ALERT SERVICE BULLETIN

AA-14108 Rev D

7 December 2016

SUBJECT: GOODRICH EXTERNAL HOIST

Figure 1. Lower limit for the 600 lb capacity hoists

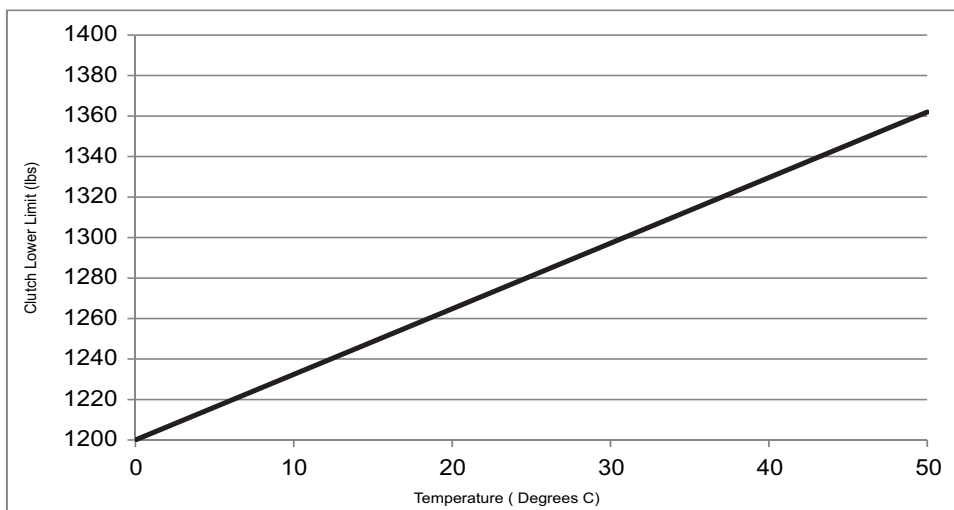
- a. If the test results indicate a value above the acceptable lower limits per Table 2 Figure 1 of Goodrich Alert Service Bulletin 44301-10-18 Revision 6, proceed with step 3.

- b. If the test results indicate a value below the acceptable lower limit per Table 2 Figure 1 of Goodrich Alert Service Bulletin 44301-10-18 Revision 6, remove the hoist from service before the next hoist operation.
